**Rother Valley Railway Transport & Works Act Order  
Footpath Diversion S&R 31 (SAL/31/1) Rail Levels**

**Approved Scheme**

**Changes to meet concerns over footpath under Bridge 12**

**Changes to meet Condition 20 Highway England Departures from Standard**

Drawing No.  
**RVR - G - 001**

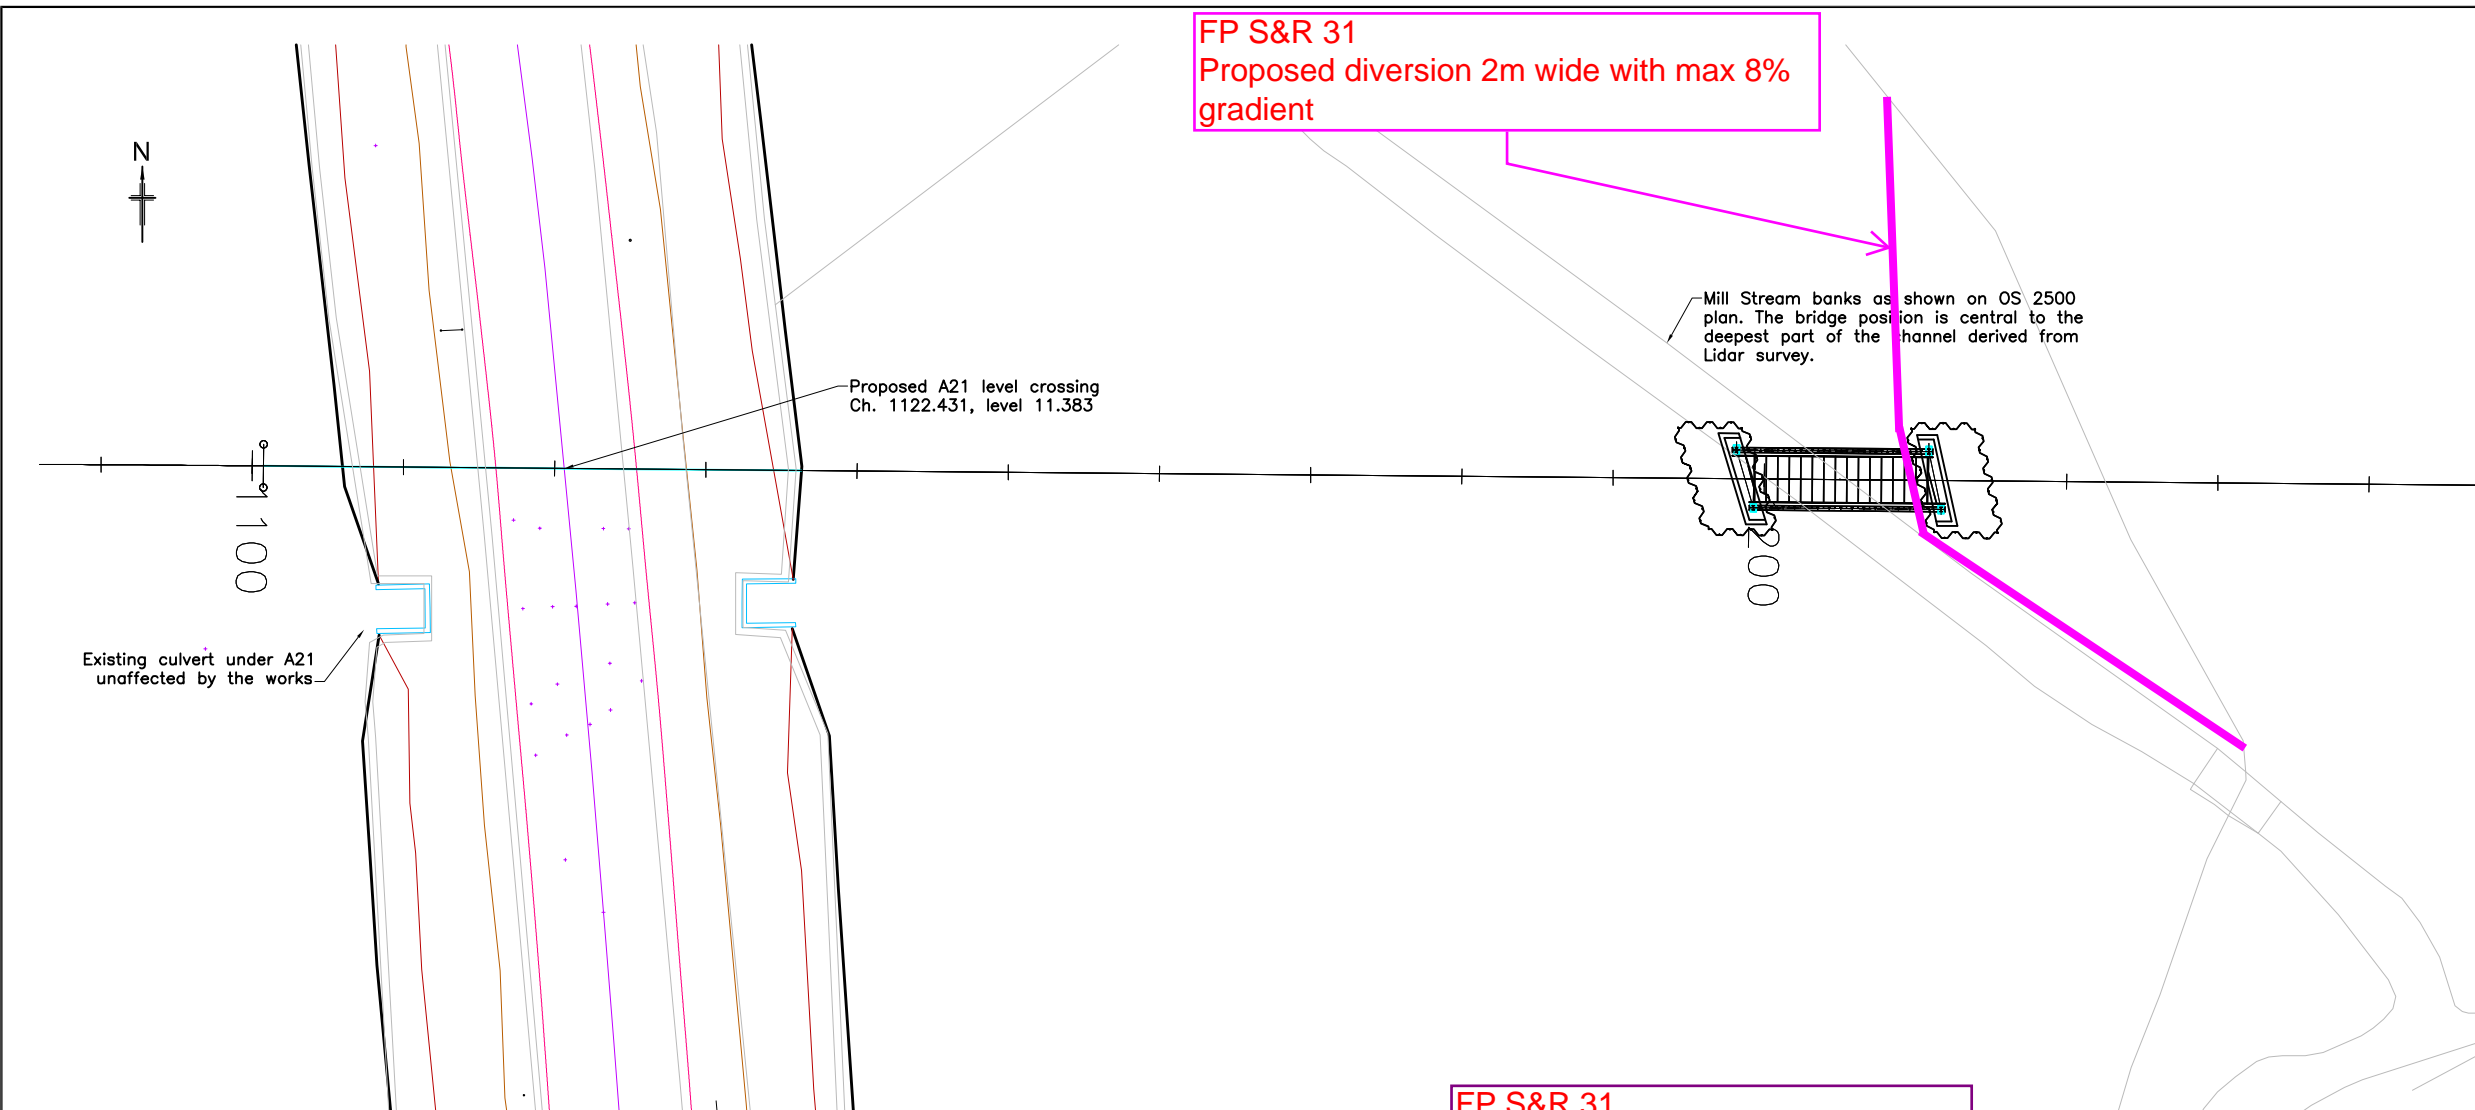
- 7 The approved profile drawing no. RVR-G-001 Rev C dated 13 June 2016 (attached at Appendix 3), shows the rail level on the east side of A21 (Ch. 1130) as 11.375 and the level at the centre of bridge 12 (Ch. 1205) as 11.230.

- 18 The flood modelling has used the top of rail level, as shown on the 2016 gradient profile drawing (RVR – G – 001 C), to set the top elevation of the embankment in the model.

- 19 At the Mill Stream crossing the flood level predicted by the model is 10.1m AOD in the 1% AEP with 105% allowance for climate change design flood event. In the gradient profile drawing (RVR – G – 001 C), the proposed Mill Stream bridge soffit is shown as 10.563m AOD and the rail level is set at 11.23m AOD. These are both above the maximum predicted flood level in the 1% AEP with 105% allowance for climate change design flood event.

Drawing No.  
**RVR - UB12 - 001** Revision  
**2**

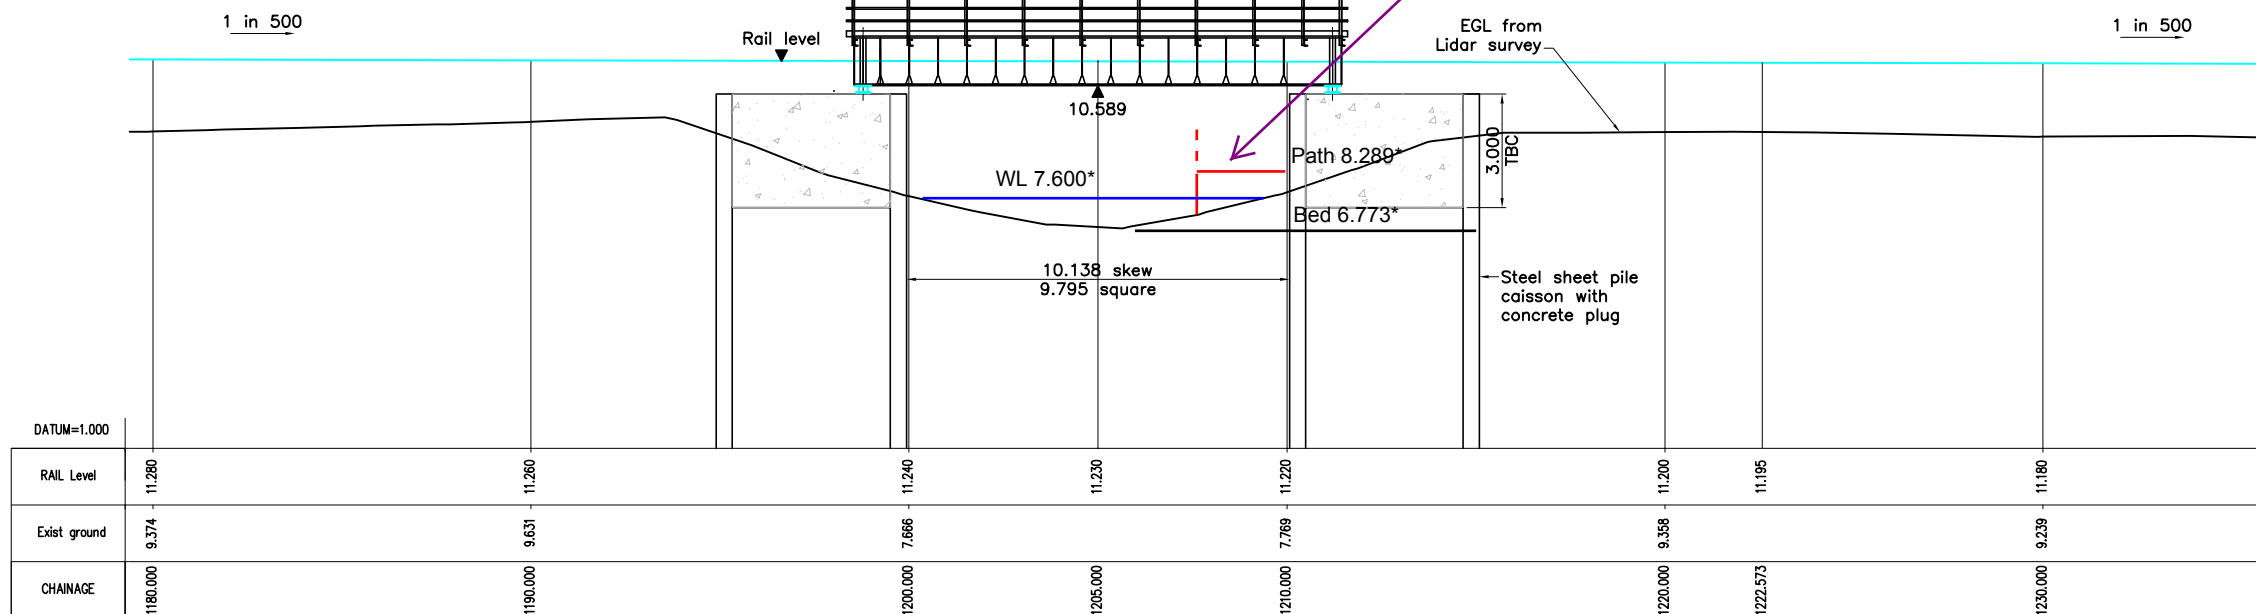
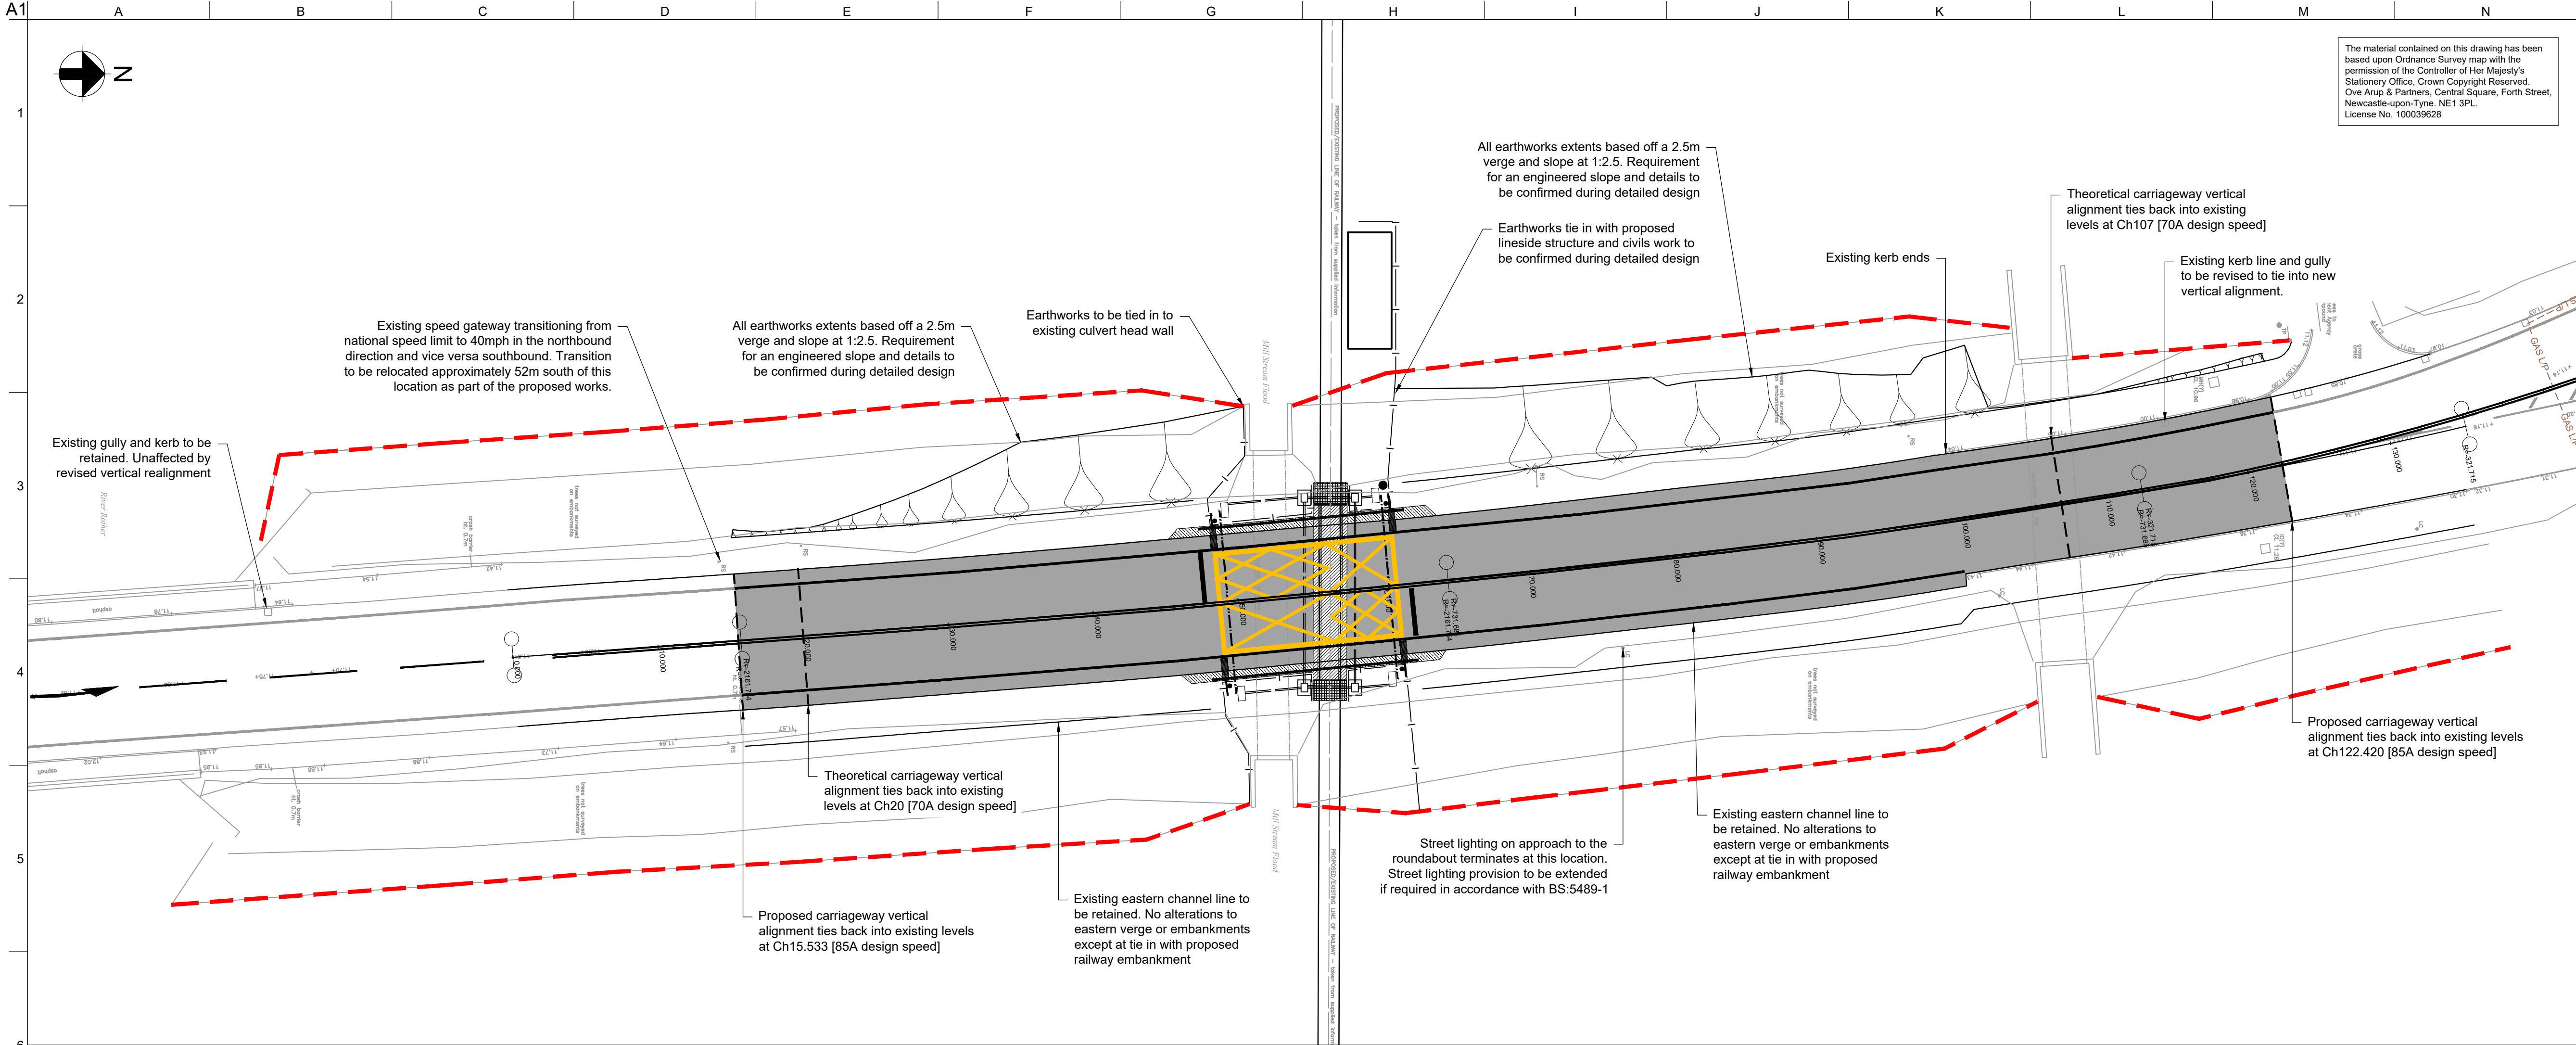
- 8 The detail of the footpath under the bridge was refined and re-submitted to Rother DC on 30 January 2017. Drawing RVR – UB12 – 001 rev 2 (attached at Appendix 4) shows the footpath diversion route with a note: "FP S&R 31 Proposed diversion 2m wide with

max 8% gradient". It also shows the footpath under the bridge with a note: "FP S&R 31 1.5m wide x 2.1m high per [www.fieldfare.org.uk](http://www.fieldfare.org.uk)" The rail level at the centre of the bridge is 11.230m AOD. No comment was received from Rother DC and the details remain to be resolved when the bridge detail drawings are submitted to Rother DC for approval following review by EA.

Arup Job No  
**239025**  
Name  
**239025-ARP-XX-XX-DR-CH-0010**

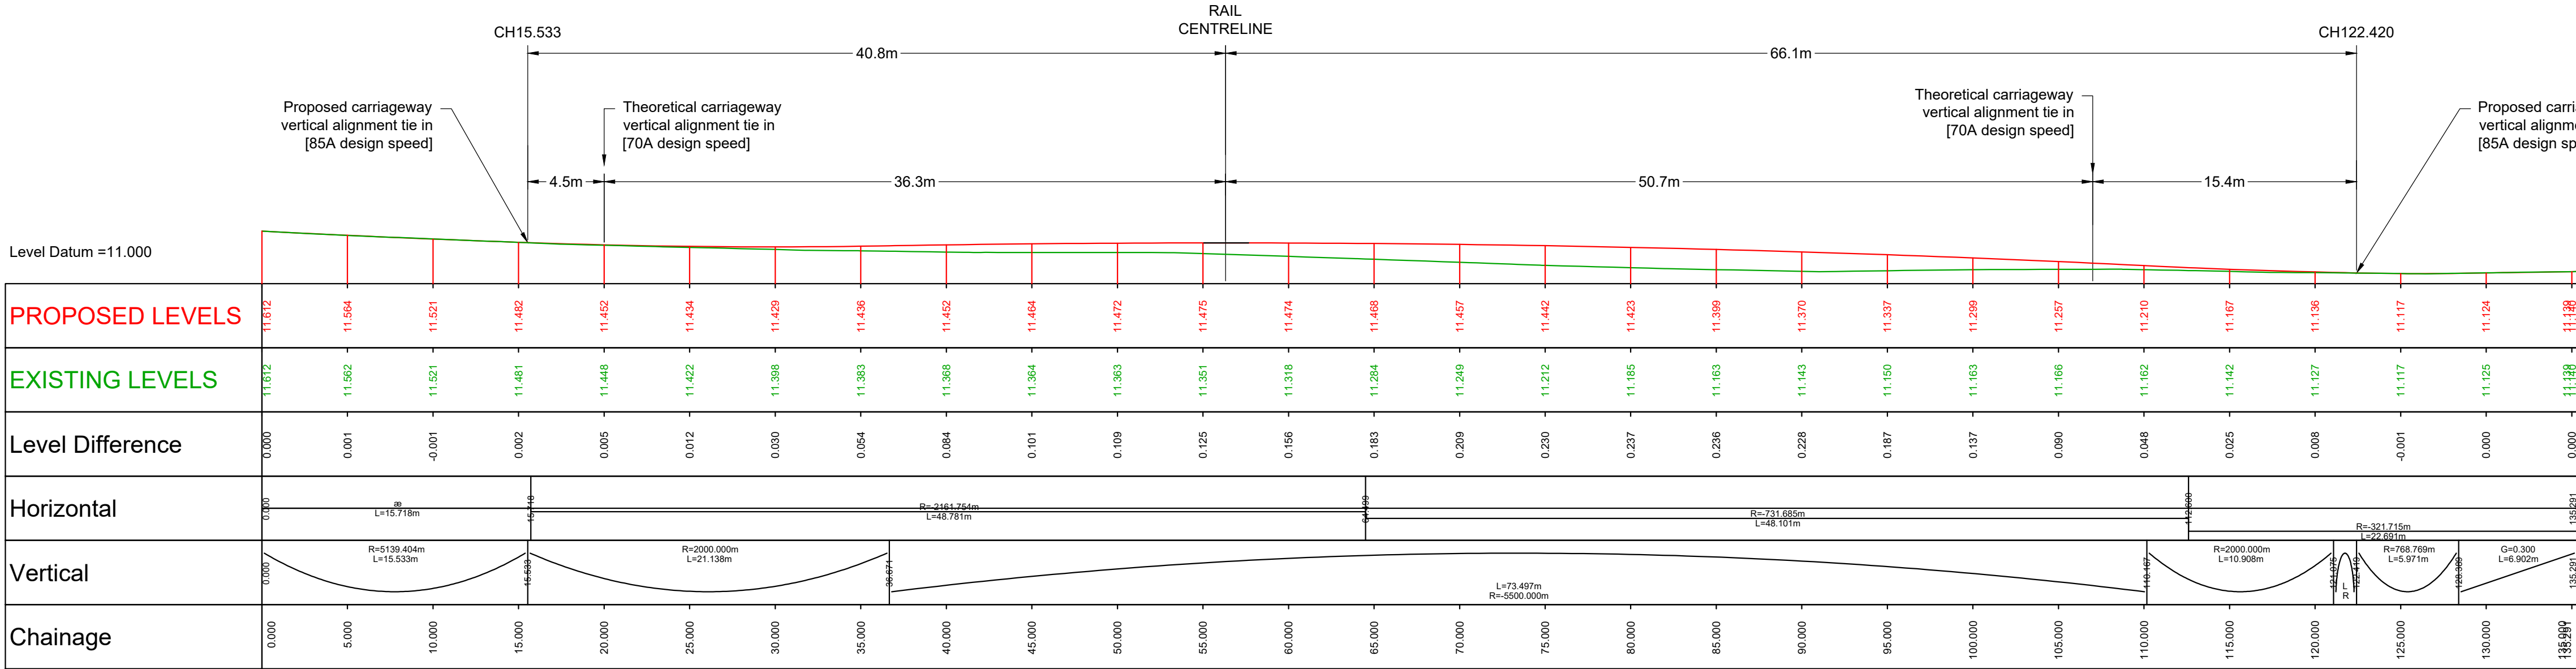
- 10 As per Departure Drawing 239025-ARP-XX-XX-DR-CH-0010\_Long\_Sec. (attached at Appendix 5), the track crosses at A21 Ch. 56.0 and the A21 centreline level is 11.475m AOD.
